Re: SEC Docket No. 2015-04 – Application of Public Service Company of New Hampshire d/b/a Eversource Energy for a Certificate of Site and Facility for the Construction of a New 115 kV Transmission Line from Madbury Substation to Portsmouth Substation (Seacoast Reliability Project)

**PRE-FILED DIRECT TESTIMONY OF MICHAEL LAWRENCE
MICHAEL LAWRENCE ASSOCIATES, PLC**

NH Seacoast Reliability Project - Aesthetic Analysis Review
Plan of Project Route
Michael Lawrence Assoc. Landscape Architects Essex Junction, Vermont 05452

Photo #8—Fox Point

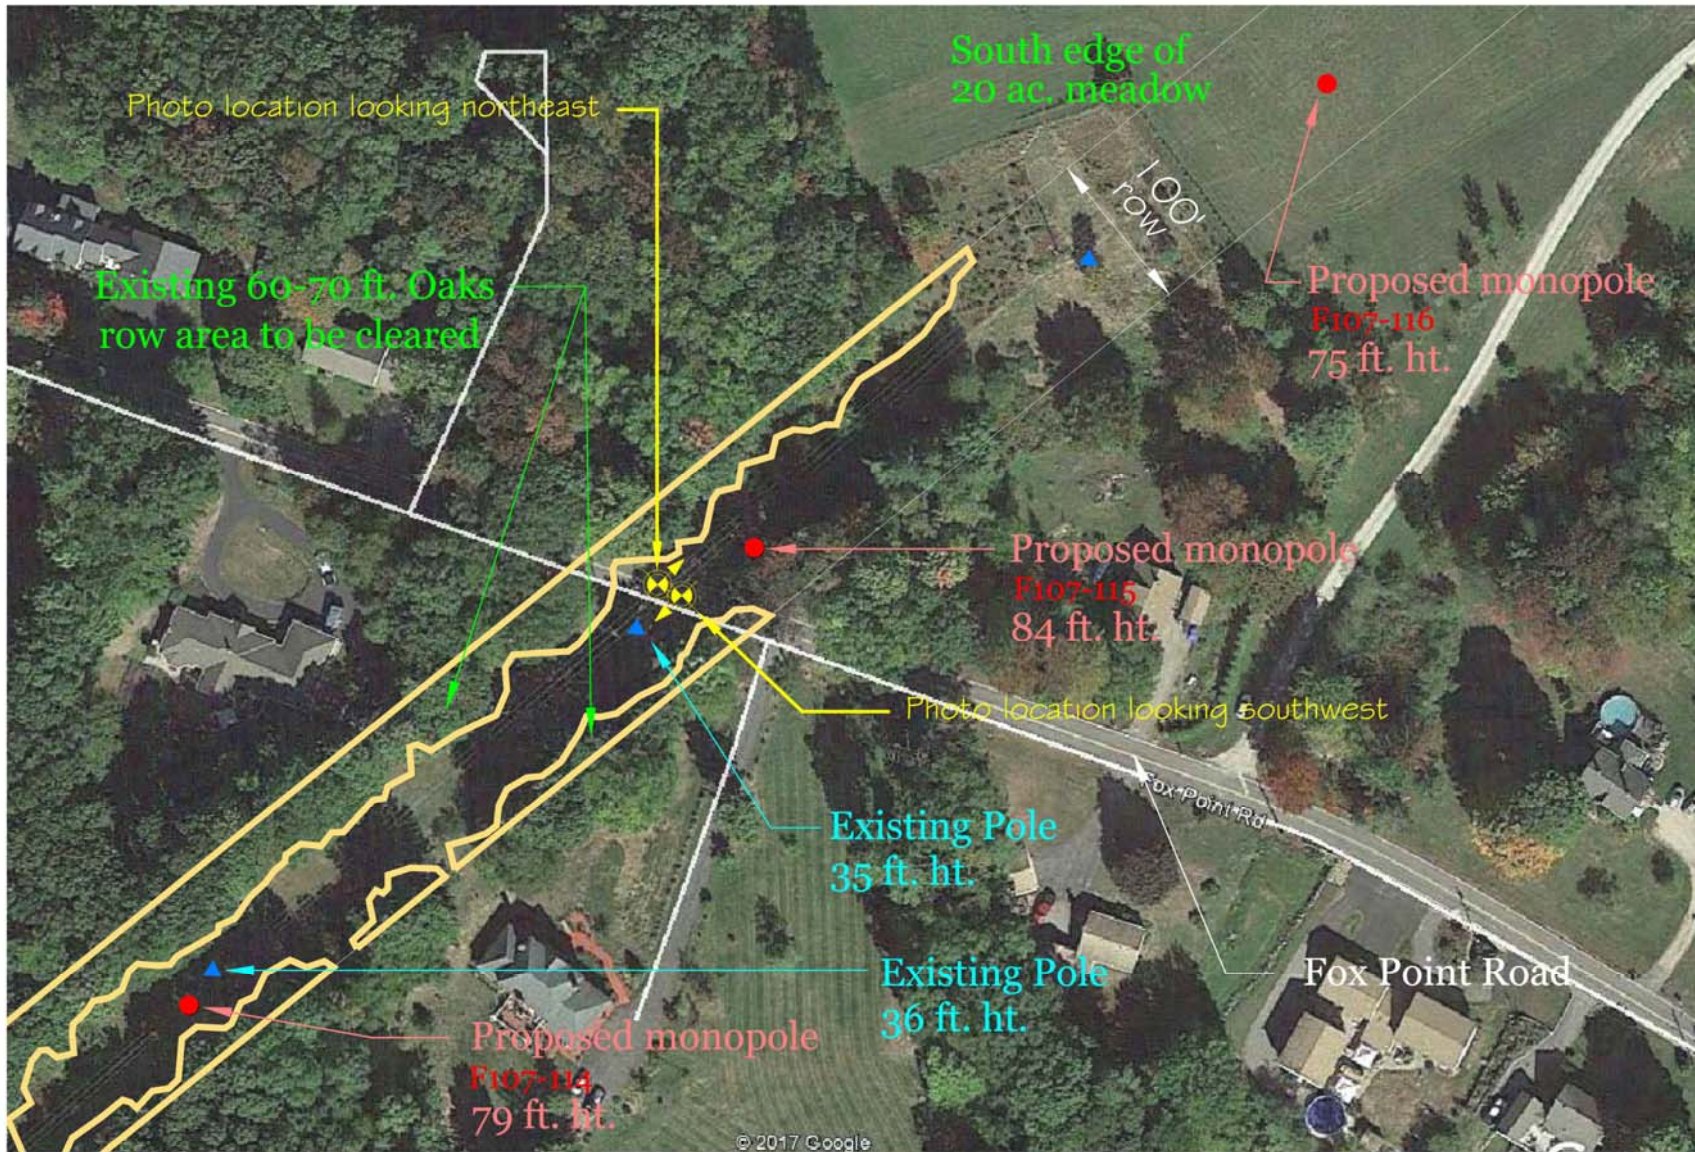
The expectation of the typical viewer looking south on Fox Point Road is to see a mix of small and large residences on wooded lots and wooded land parcels. This expectation includes not seeing structures grossly out of scale with the one and two story residences.

Engineering plans indicate a 79 ft. pole (F107-114) approximately 400 ft. south of Fox Point Road and triple 55 ft. tall poles 640 ft. further. Clearing and significantly higher poles (twice as high) will dramatically alter the character of this view at the crossing.

Opening the ROW, placing a tall structure close to the road, and replacing the existing poles running north with structures nearly twice as high will represent a major change in north views from the Fox Point Road crossing.

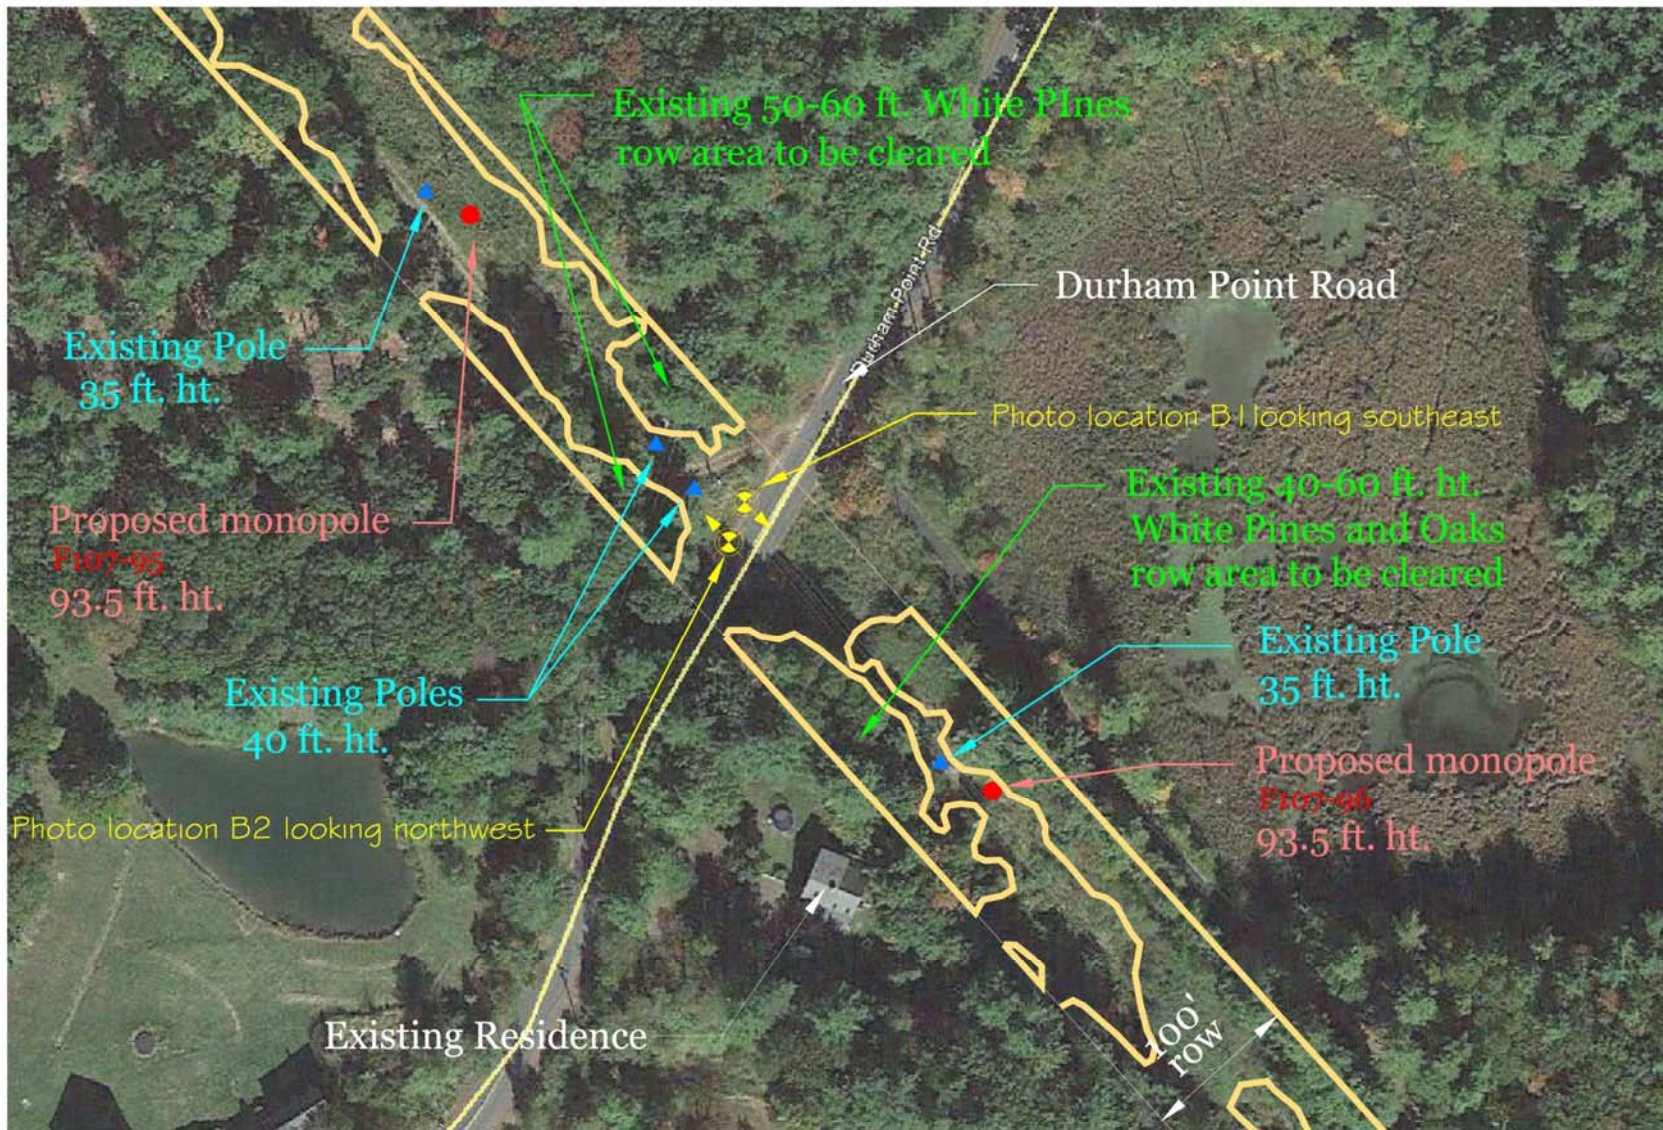
The new line heads in a straight line southwest from Durham Point Road for .03 mi. along four new single-pole structures (F-107-96, 97, 98 and 99) that range in height from 66-98 ft. Because grade is relatively level, the 100 ft. wide clearing will expose the new poles and wires along this section of the project from Durham Point Road.

A 93 ft. ht. pole (F107-96) is proposed just south of the existing pole closest to Durham Point Rd. The higher, unscreened pole standing out against the sky will attract attention to itself, altering the view looking southeast at the Durham Point Road crossing.

Photo #27—LOCATION G2 (Route 108 Crossing) looking east along proposed project—June, 2017 55 mm eq.

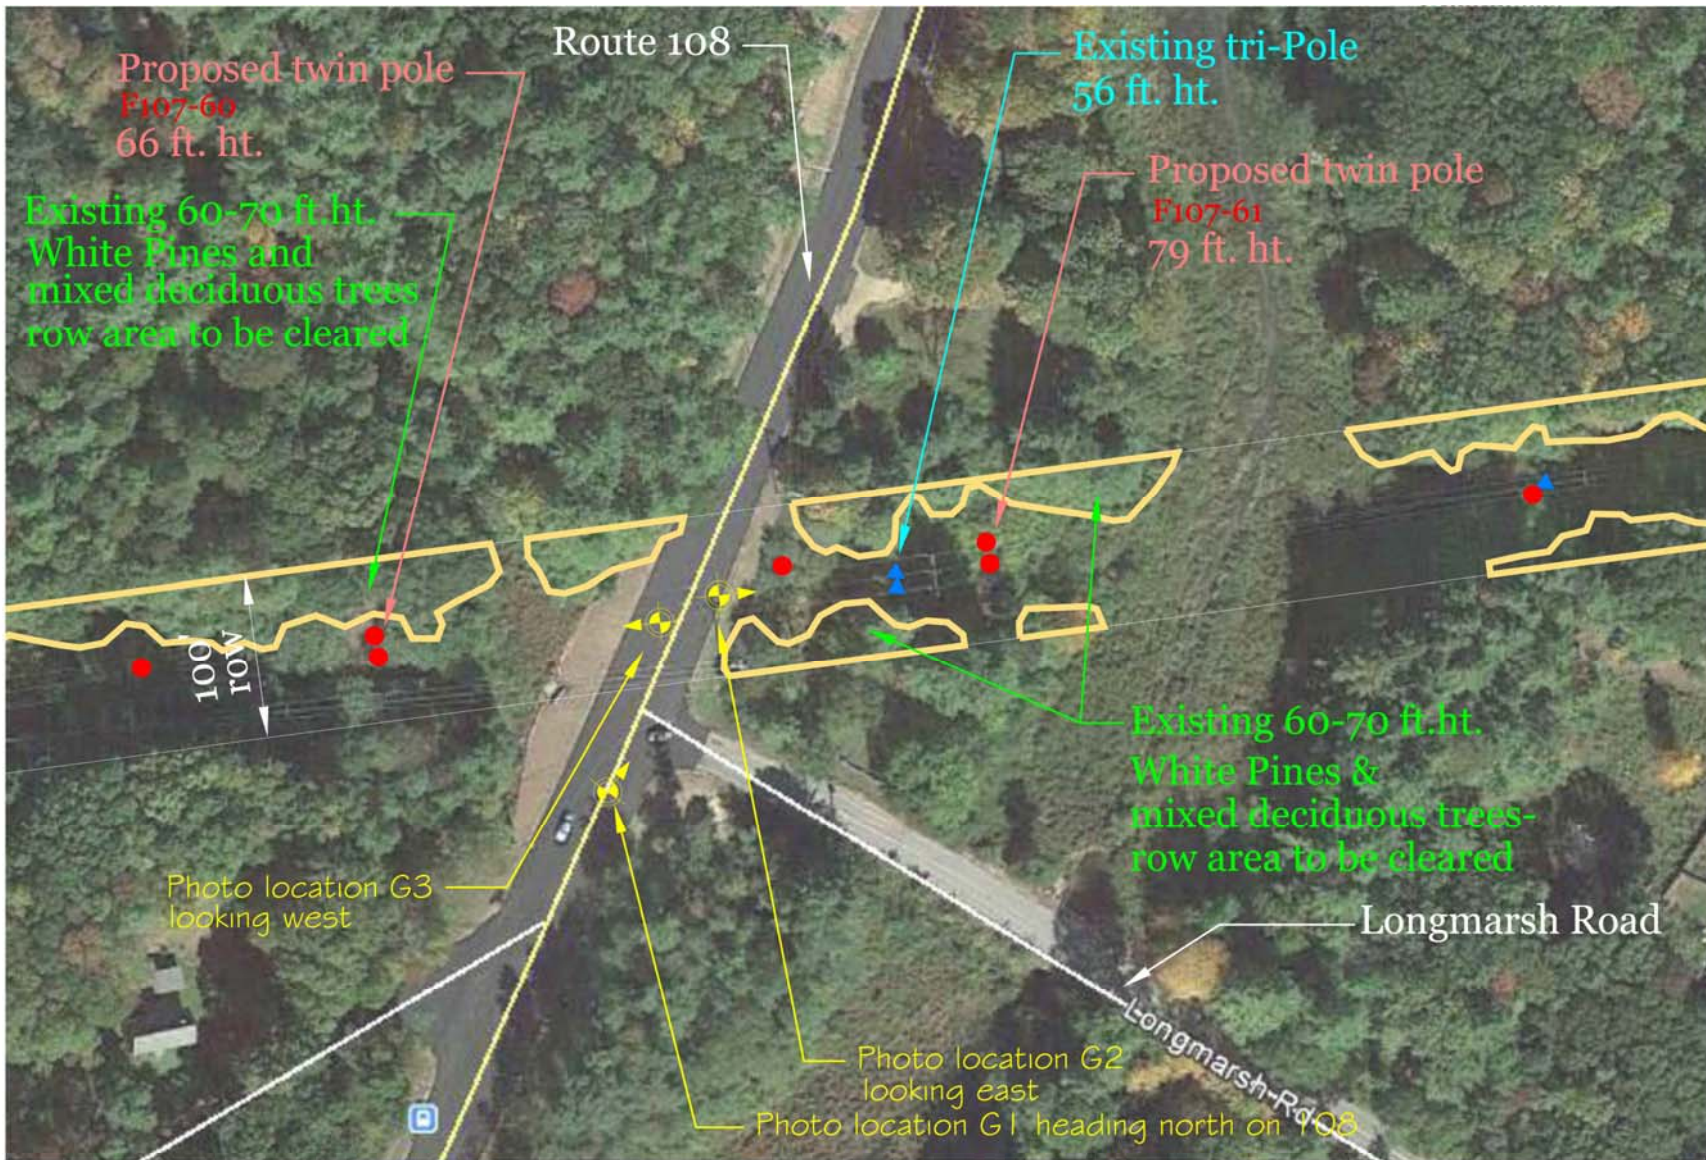
Environmental Maps 10 /28 and 11/28 and engineering drawings indicate a 100 ft. wide clearing and the installation of higher poles including 79 ft. ht. (F107-61) 150 ft. from the road, 70 ft. ht. (F107-62) 300 ft. further and 79 ft. ht. (F107-63) 400 ft. beyond.

NH Seacoast Reliability Project - Aesthetic Analysis Review
 H. Mill Road Crossing
 Clearing diagram with tree and pole heights

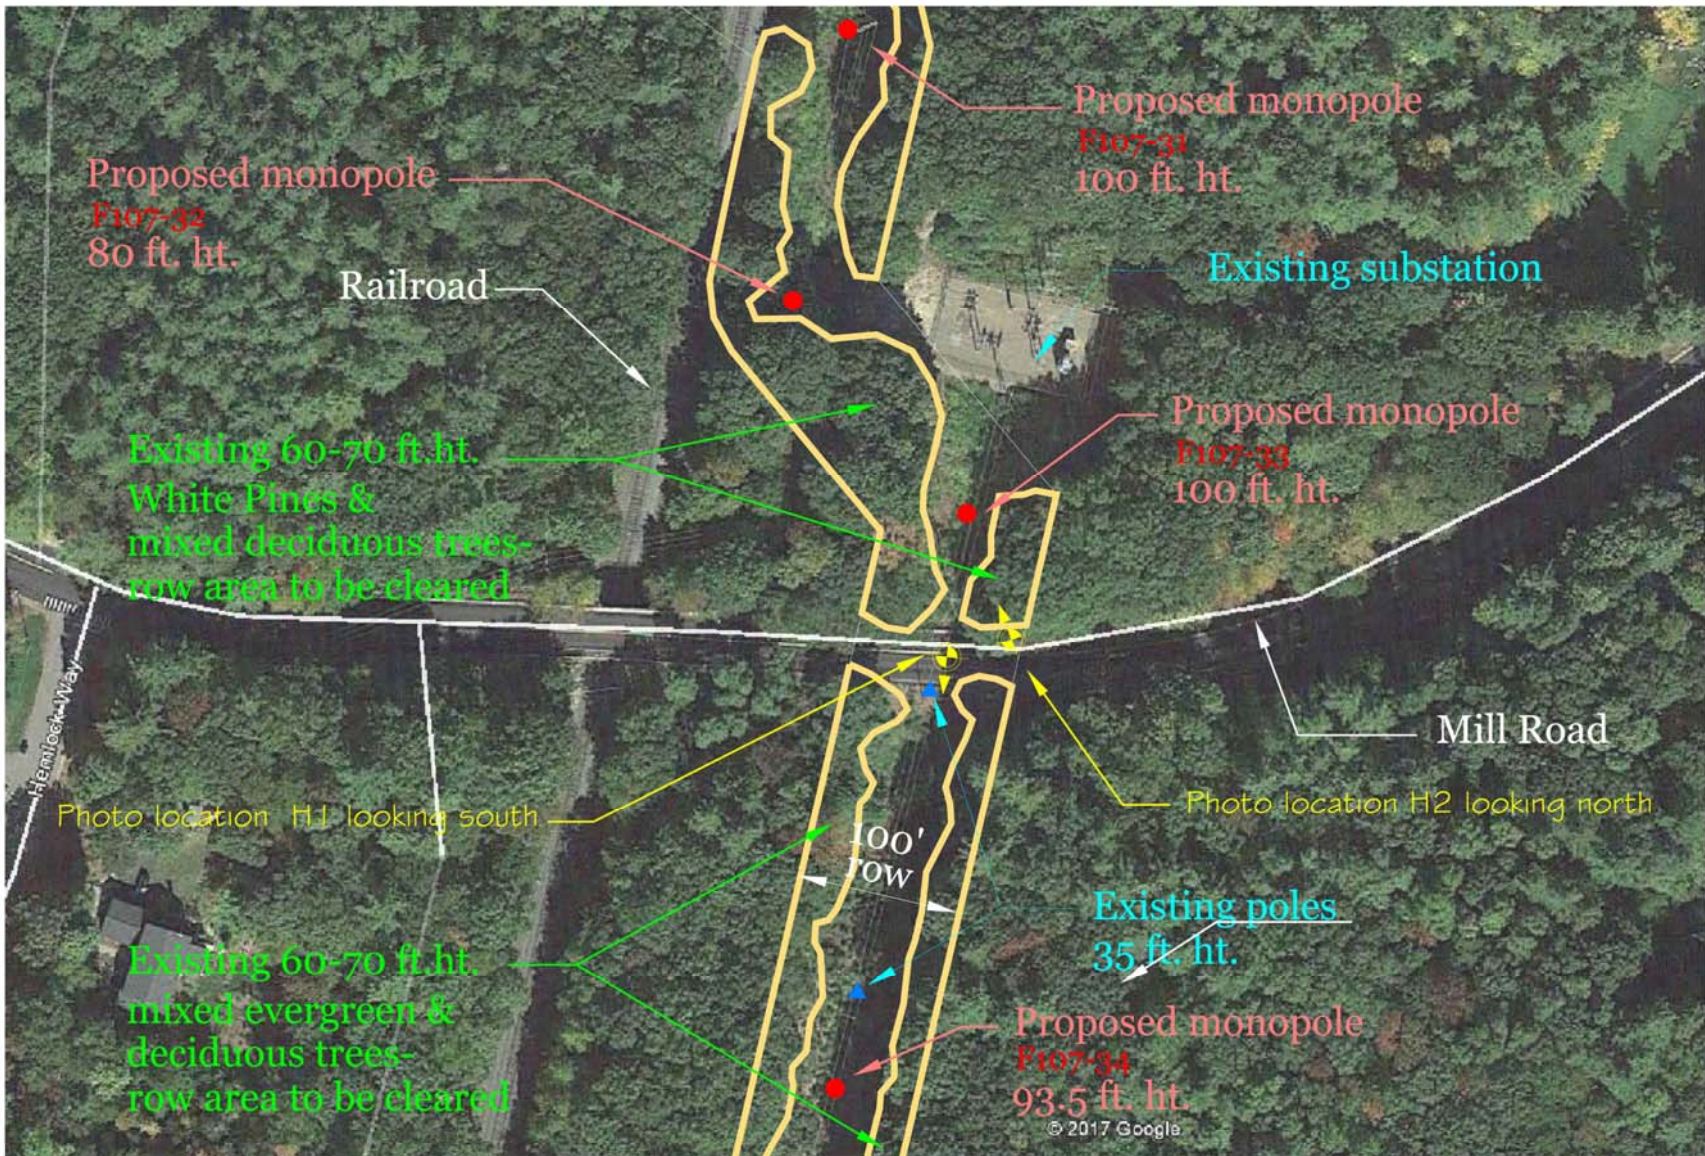
Environmental Map 6/28 depicts clearing the 100 ft. ROW north of Mill Road. Five new poles starting with 93 ft. tall F107-34, 275 ft. south of the road and four more between 84 and 93 ft. tall (F107-35-F107-38) extend in a straight line for the next 1,700 ft.

The combination of additional clearing and high poles (twice to three times the height of existing) nearby and extending into the distance will result in greater visibility, an increased silhouette in the sky, a bigger interruption in the wooded character of the road, creating a different character looking south at the Mill Road crossing.

Photo #32—LOCATION I1 (UNH—Gregg Hall Vicinity) looking east toward proposed project from north side of Gregg Hall June, 2017—

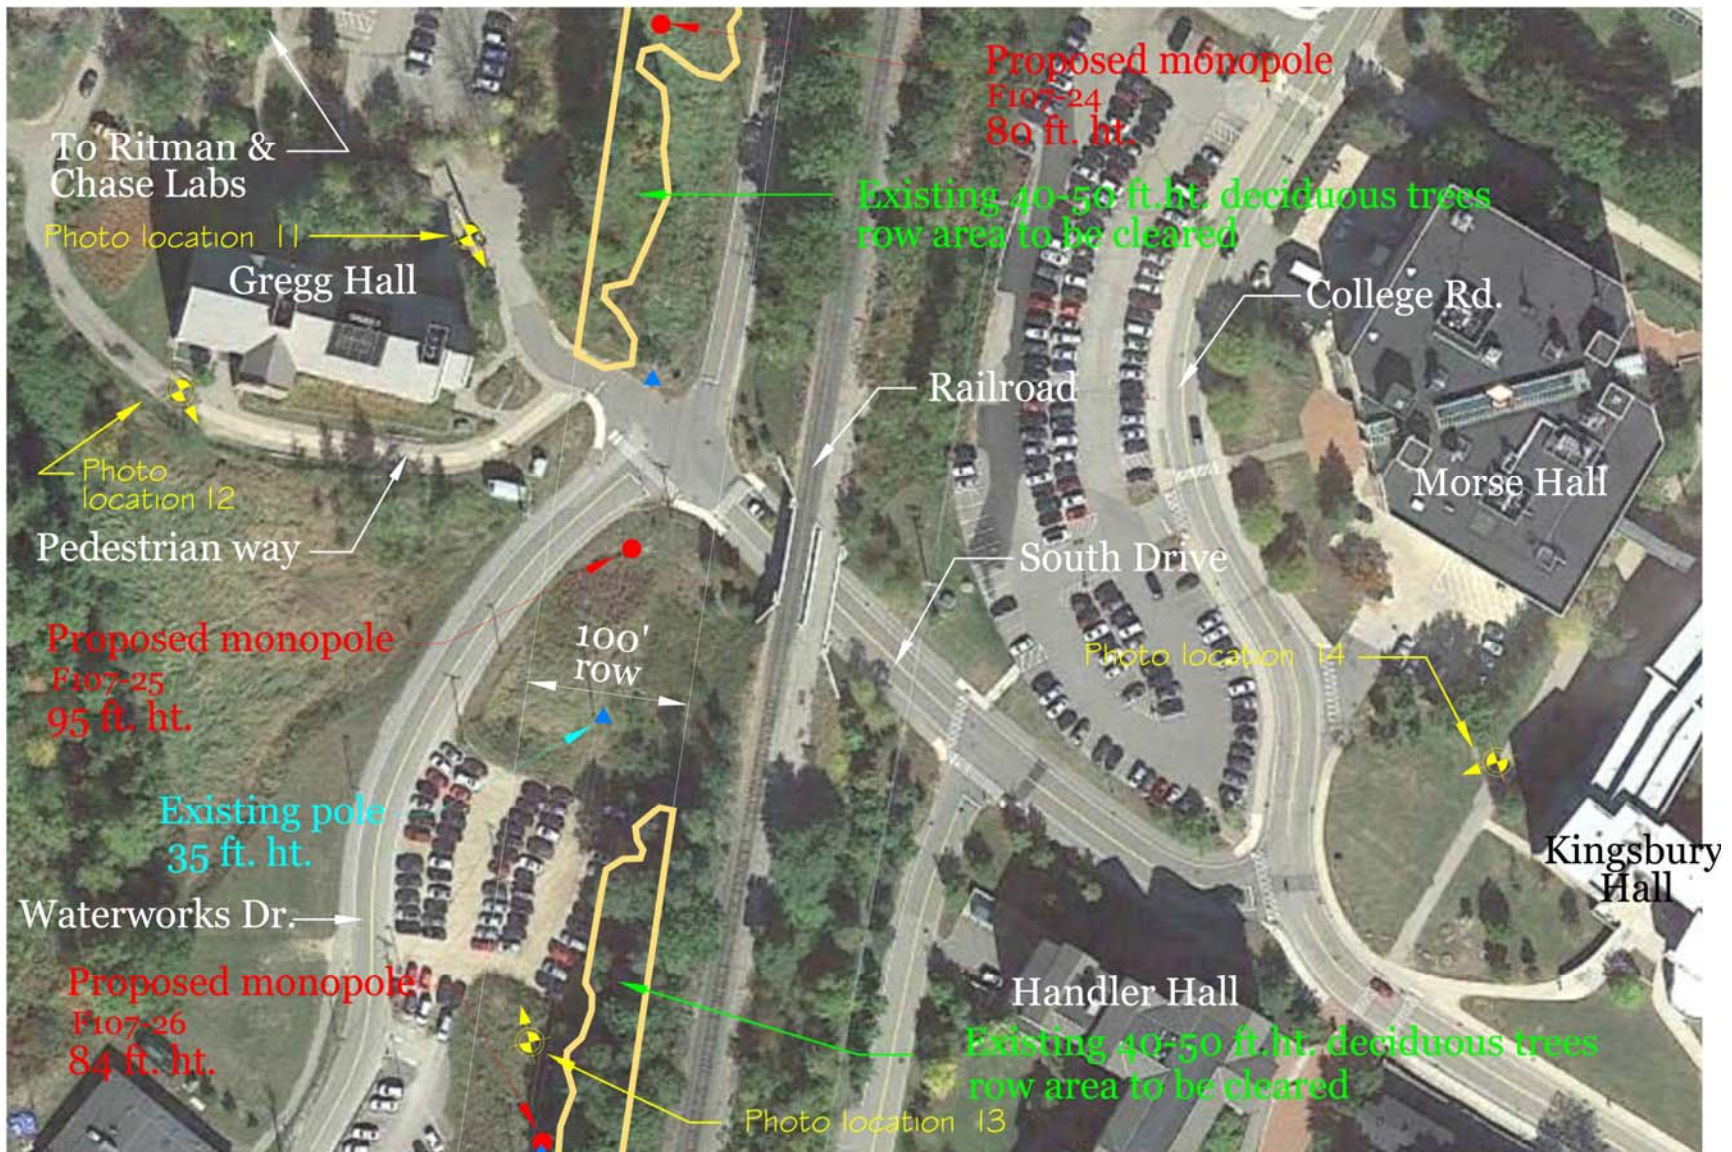
Environmental Map 5/28 show a 95 ft. pole (F107-25) about 50 ft. south of the South Drive/Waterworks Road intersection. It also indicates that 30 ft. of vegetation growing alongside the railroad right of way starting 175 ft. south of South Drive and extending for 750 ft. will be cleared. This run will include four more new poles, 84 ft. ht. (F107-26), 84 ft. ht. (27), and 93 ft. ht. (28).

The extent of clearing indicated on the environmental map raises questions about the amount and quality of the vegetation to remain. This is a relatively narrow body of tightly connected vegetation with foliage along its entire west face.

While the LW's report states (page 104) that, "*this area of campus is already well-established with University infrastructure and includes physical plant buildings adjacent to it, providing a sense that portions of this area are part of the University's more utilitarian and functional areas—not primary campus focal points or gathering areas.*" these are not valid reasons to allow the visual quality to be further eroded.
